Job: TH - Walled Garden Buildings

Title: Door Details - DTB7 P2
Door Type - B7
Sheet 2 of 3

Type: Building 16 & 16a

Status: FOR PLANNING

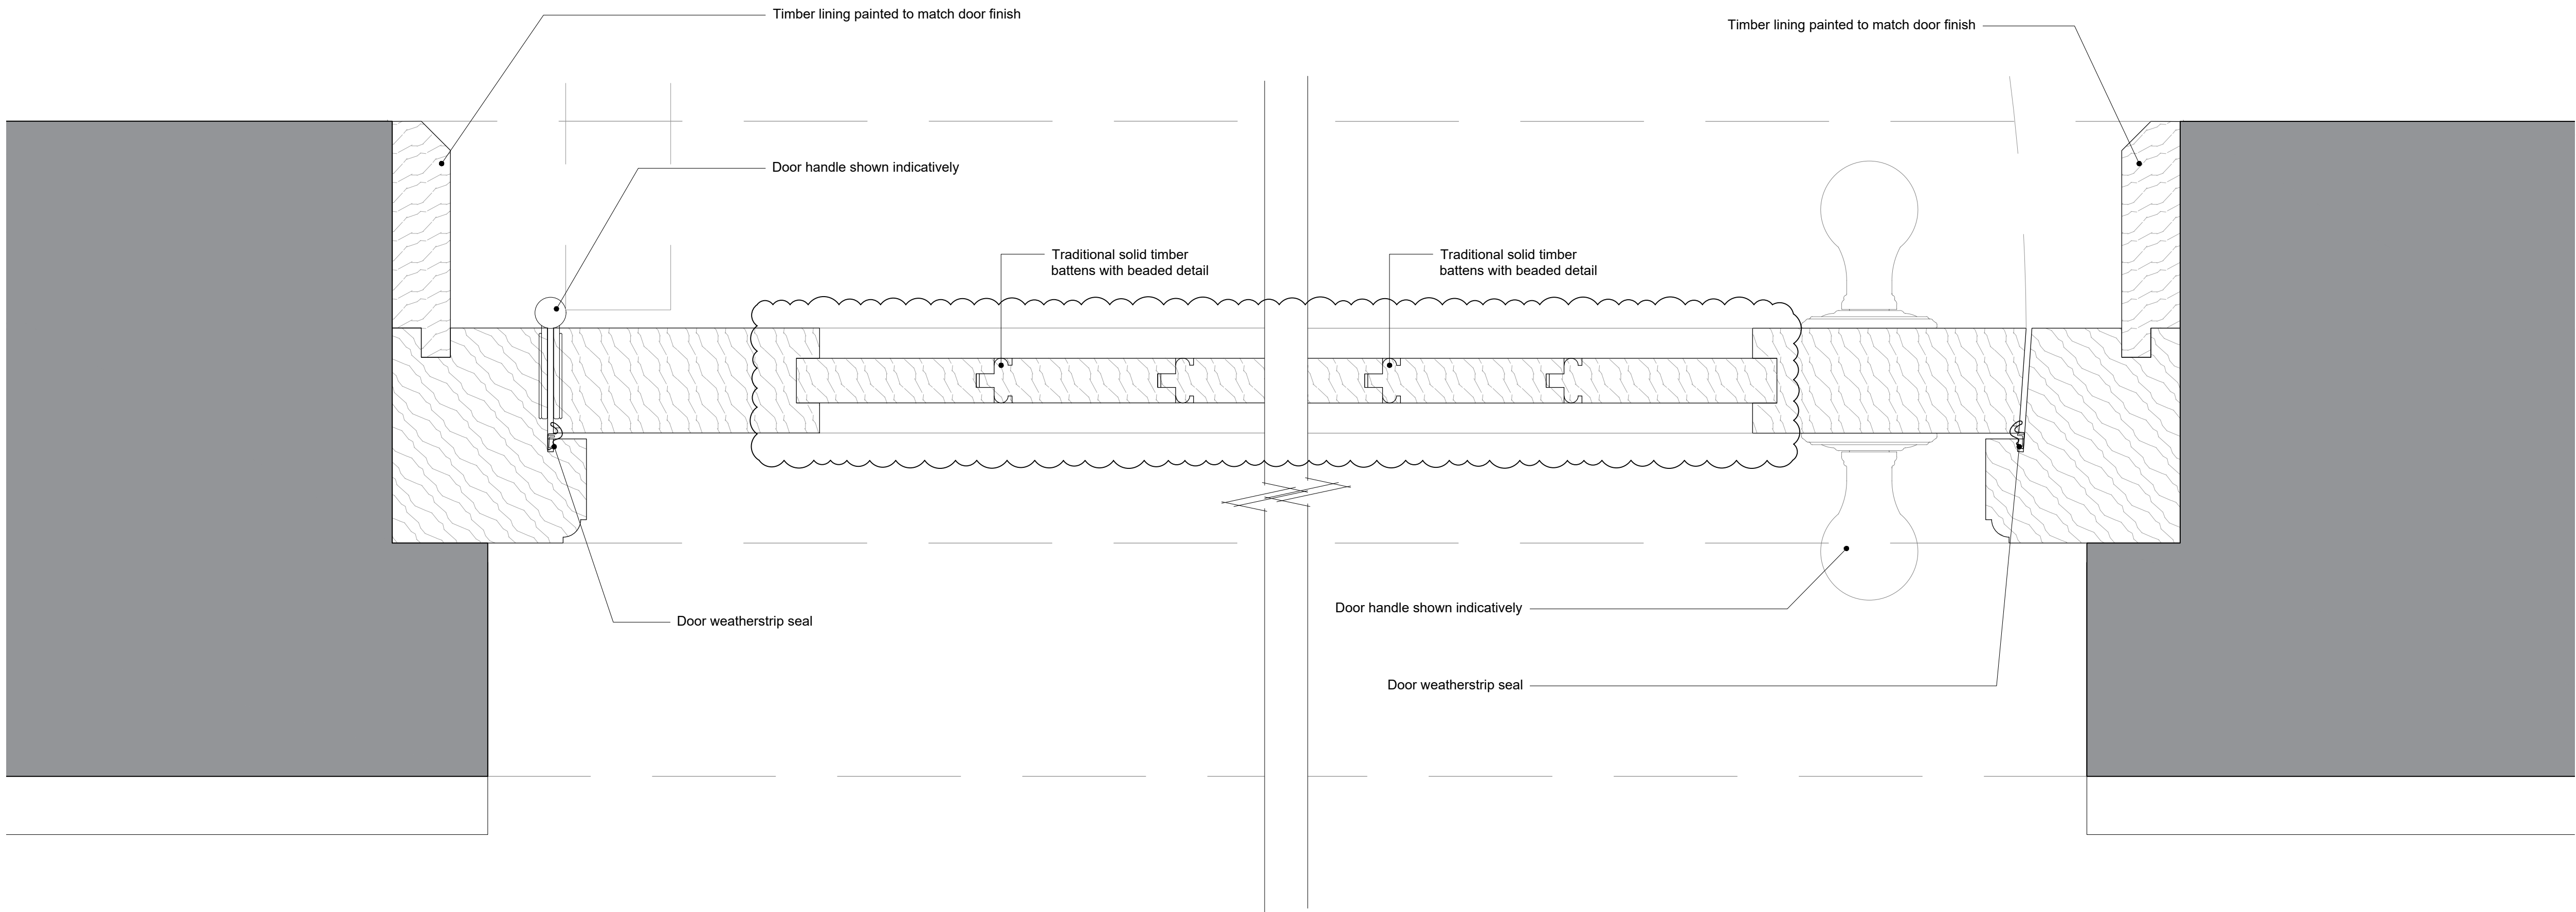
P2	Door amended to traditional timber frame and battened door with beaded detail following officers' comments. Details titles updated. Scale Bar Amended. Intumescent seal omitted.	26/03/26
P1	Initial Release	dd/mm/yy
no.	revision.	date.
